Access Compliance Report

Public Rights-of-Way

(Curb Ramps)

Intersection ID: 52453	Main Street: PAT_GARRETT_ST	Cross Street: DOUBLE_OAKS_RD	Location: SW
ADA ID: F7886EDC3F6E	Ramp Type: Perp	Initial Pass/Fail: Fail	Overall Compliance: No
		Severity Score: 12.5

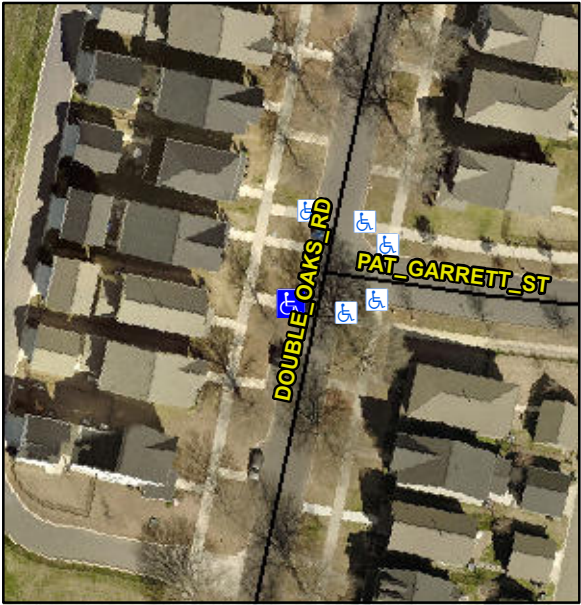
Codes/Mitigation Info/Possible Solution			Field Measurements/Component Compliance		
	Possible Solutions:		Compliance	Description	Data
	Remove & Replace Entire Ramp.		N/A	Ramp Length (in)	86.0
			Yes	Ramp Width (in)	66.0
			N/A	Flare Type LT	N/A
			N/A	Flare Slope LT (%)	N/A
			N/A	Flare Traversable LT?	N/A
			N/A	Landing Length (in)	N/A
			N/A	Landing Width (in)	N/A
			N/A	Landing Slope (%)	N/A
			N/A	Landing X Slope (%)	N/A
<p>Surveyor Notes:</p> <p>N/A</p> <p>PROW/ADA:</p> <p>Not Found, R304.2.2</p>			N/A	Flare Type RT	N/A
			N/A	Flare Slope RT (%)	N/A
			N/A	Flare Traversable RT?	N/A
			N/A	DWS Provided?	N/A
			N/A	DWS Contrast?	N/A
			N/A	DWS Length (in)	N/A
			N/A	DWS Full Width?	N/A
			N/A	DWS Offset (in)	N/A
			N/A	Shared Landing?	N/A
			N/A	Gutter Ponding?	N/A
			N/A	Gutter Lip Ht (in)	2.0
			N/A	Painted X Walk1?	No
				X Walk 1 Direction	To E
			N/A	X Walk 1 Width (in)	N/A
				X Walk 1 Slope (%)	3.3
				X Walk 1 X Slope (%)	1.0
